Intersection ID: 26923	Main Street: PLAYFAIR_LN	Cross Street: SETON_HOUSE_LN	Location:	W
ADA ID: 291FA5573C4E	Ramp Type: PerpDiag	Initial Pass/Fail: Fail	Overall Compliance: No	Severity Score: 33.75

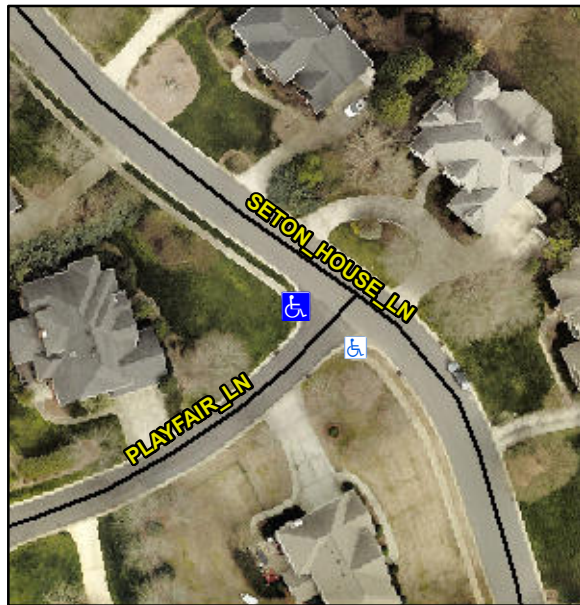
Compliance	Description	Data	Compliance	Description	Data
N/A	Ramp Length (in)	46.5	Yes	Ramp Slope (%)	5.0
No	Ramp Width (in)	39.5	No	Ramp XSlope (%)	14.6
N/A	Flare Type LT	N/A	N/A	Flare Type RT	N/A
N/A	Flare Slope LT (%)	N/A	N/A	Flare Slope RT (%)	N/A
N/A	Flare Traversable LT?	N/A	N/A	Flare Traversable RT?	N/A
N/A	Landing Length (in)	N/A	N/A	DWS Provided?	N/A
N/A	Landing Width (in)	N/A	N/A	DWS Contrast?	N/A
N/A	Landing Slope (%)	N/A	N/A	DWS Length (in)	N/A
N/A	Landing X Slope (%)	N/A	N/A	DWS Full Width?	N/A
N/A	Landing Curb? (Y/N)	N/A	N/A	DWS Offset (in)	N/A
N/A	Shared Landing?	N/A			
N/A	Gutter Ponding?	N/A	N/A	Gutter Slope (%)	N/A
N/A	Gutter Lip Ht (in)	N/A	N/A	Gutter X Slope (%)	N/A
N/A	Painted X Walk1?	No	N/A	Painted X Walk2?	No
	X Walk 1 Direction	To SE		X Walk 2 Direction	To NE
N/A	X Walk 1 Width (in)	N/A	N/A	X Walk 2 Width (in)	N/A
	X Walk 1 Slope (%)	7.0		X Walk 2 Slope (%)	8.6
	X Walk 1 X Slope (%)	8.5		X Walk 2 X Slope (%)	11.8

N/A	Ramp inside XWalk1?	N/A	N/A	Ramp inside XWalk2?	N/A
	Road Slope (%)	11.3	N/A	Clear Space?	N/A
	Road X Slope (%)	2.2	N/A	Clear Space to XWalk (in)	N/A
N/A	Any Obstructions?	N/A	N/A	Storm Grate/Utility Hazard?	N/A
	Obstruction Type			Storm Grate/Utility Type	
		N/A			N/A
			Yes	Surface Condition? (G/P)	Good

**Remove & Replace Curb Ramp With Two New Directional Ramps or Equivalent.**
